Access Compliance Report

Public Rights-of-Way

(Curb Ramps)

Intersection ID: 50707	Main Street: CONGREGATION_DR	Cross Street: BROTHERLY_LN	Location: SE
ADA ID: 1054B8EAC9CB	Ramp Type: Perp	Initial Pass/Fail: Fail	Overall Compliance: No
Severity Score: 8.75			
Codes/Mitigation Info/Possible Solution		Field Measurements/Component Compliance

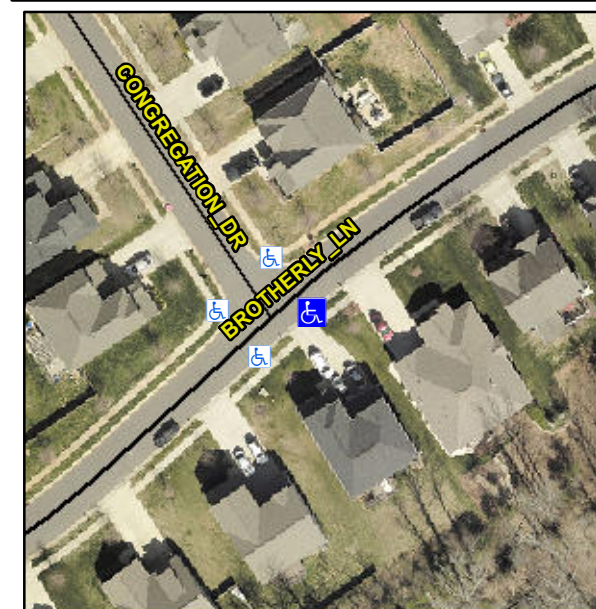
Not Found, R304.5.1

Compliance	Description	Data	Compliance	Description	Data
N/A	Ramp Length (in)	49.0	Yes	Ramp Slope (%)	7.3
No	Ramp Width (in)	47.0	Yes	Ramp XSlope (%)	0.7
N/A	Flare Type LT	N/A	N/A	Flare Type RT	N/A
N/A	Flare Slope LT (%)	N/A	N/A	Flare Slope RT (%)	N/A
N/A	Flare Traversable LT?	N/A	N/A	Flare Traversable RT?	N/A
N/A	Landing Length (in)	N/A	N/A	DWS Provided?	N/A
N/A	Landing Width (in)	N/A	N/A	DWS Contrast?	N/A
N/A	Landing Slope (%)	N/A	N/A	DWS Length (in)	N/A
N/A	Landing X Slope (%)	N/A	N/A	DWS Full Width?	N/A
N/A	Landing Curb? (Y/N)	N/A	N/A	DWS Offset (in)	N/A
N/A	Shared Landing?	N/A			
N/A	Gutter Ponding?	N/A	N/A	Gutter Slope (%)	N/A
N/A	Gutter Lip Ht (in)	N/A	N/A	Gutter X Slope (%)	N/A
N/A	Painted X Walk1?	No	N/A	Painted X Walk2?	N/A
	X Walk 1 Direction	To NW		X Walk 2 Direction	N/A
N/A	X Walk 1 Width (in)	N/A	N/A	X Walk 2 Width (in)	N/A
	X Walk 1 Slope (%)	2.5		X Walk 2 Slope (%)	N/A
	X Walk 1 X Slope (%)	1.8		X Walk 2 X Slope (%)	N/A

Remove & Replace Entire Ramp.
